DATE: 12.28.2012

FROM: Tara S. Murphy, ASLA/RLA/LEED AP
Transportation Planning

■ **FIAT OF WILMINGTON [2nd Review]**

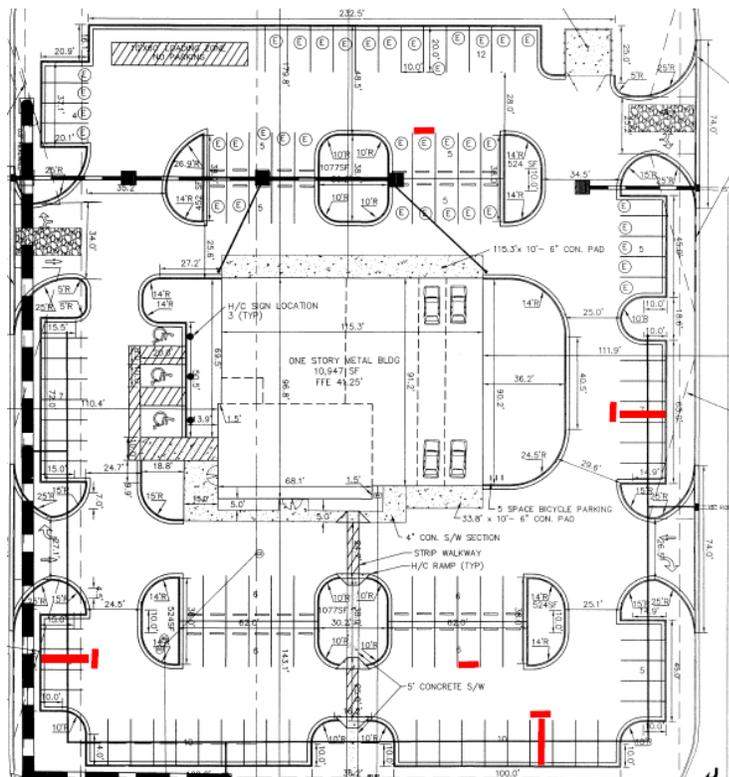
1. Please indicate the **visitor/customer** spaces. (You indicated the employee spaces in the resubmittal)
2. Show and apply the City's 20'x70' sight distance triangle at each driveway (4 locations off the Private Roads) on the site plan and landscaping plan. [\[Sec.18-529\(c\)\(3\)CofW LDC\]](#) **All look as discussed with the exception of the westernmost driveway – the ingress side needs to be shifted so the triangle is aligned with the face of curb. Please revise.**
3. Dimension parking stalls, radii and parking aisles. [\[Sec. 18-529\(b\)\(2\) CofW LDC\]](#) **Specific to those as indicated below;**
